**PSSM at Damascus, Mandatory Referral, MR2020011**

**PSSM at Damascus: MR2020011**

**Staff Recommendation: Approval with Comments**

Figure 5: Tower Design

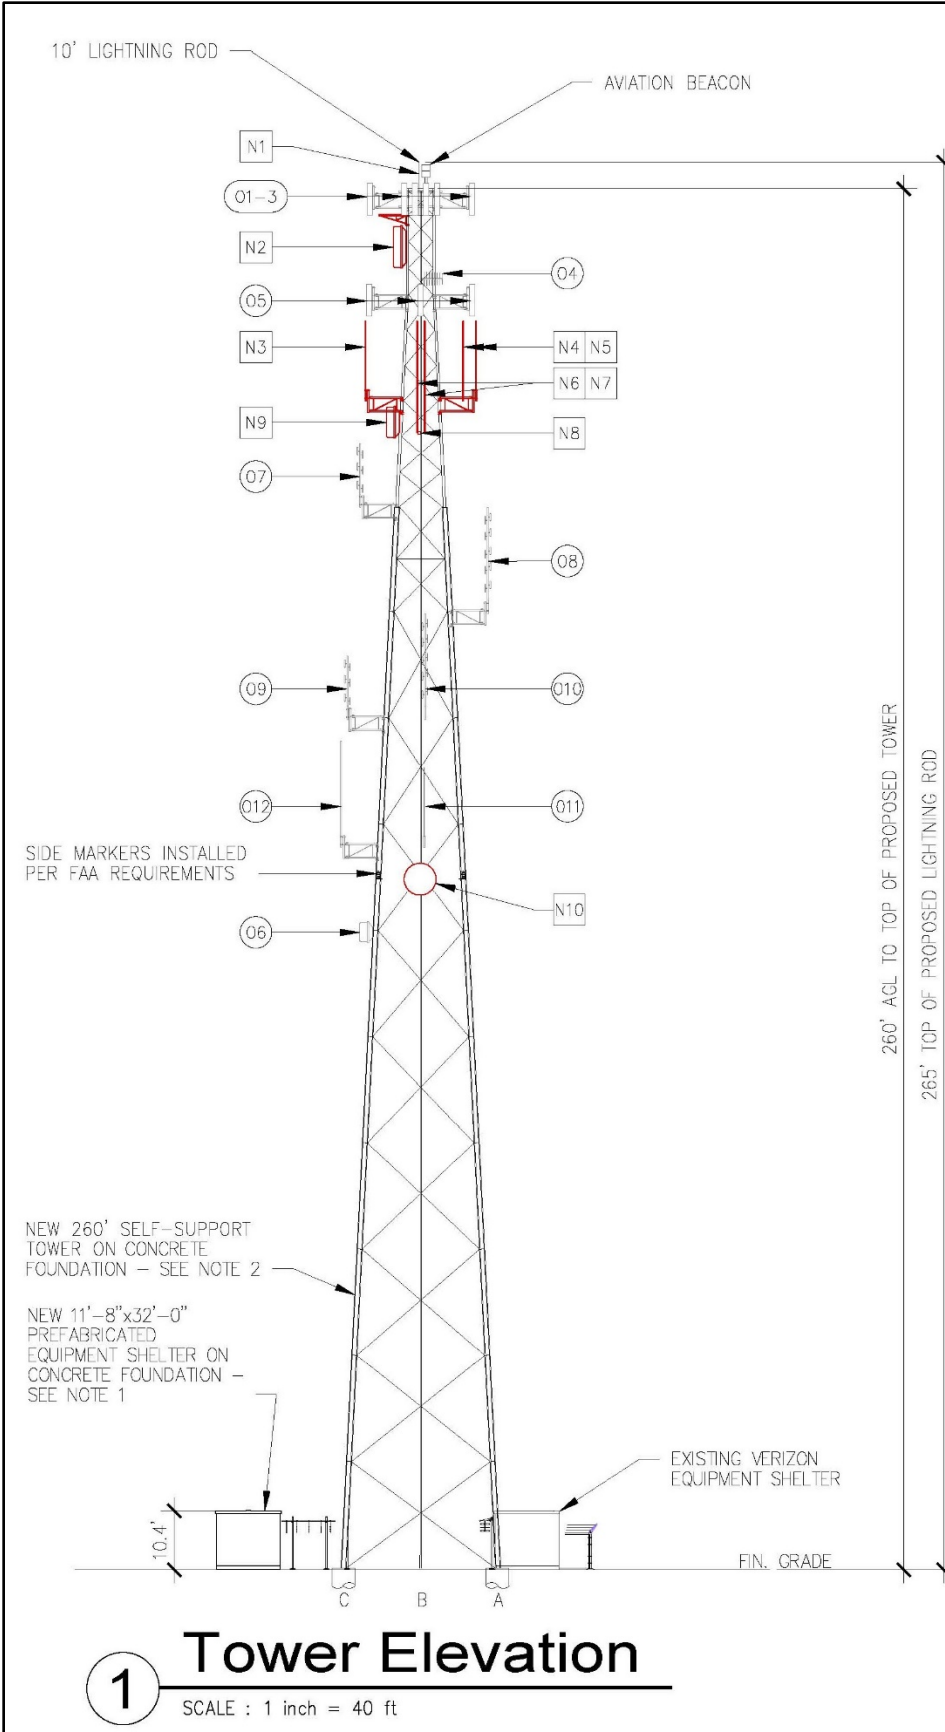
The 260’ Class III lattice tower with a 10’ lightning rod will be a total of 270 feet in height and located at 26149 Ridge Road and will replace the existing 252 foot tower currently onsite. The industry standard, red and white strobes will be installed as a beacon on the tower.

The tower will be built to Structure Class III standards, which has a “return period” of 1700 years. This means the observed wind speed is statistically likely to meet or exceed the design wind load only once every 1700 years. According to the applicant, Class III structures are capable of withstanding storms that would otherwise devastate nearby structures, and these structures are frequently among the last structures standing after a catastrophic weather event.

The proposed height of 270 feet (including lightning rod does exceed the height normally allowed under a Conditional Use, however; the height is necessary for public safety communication purposes.
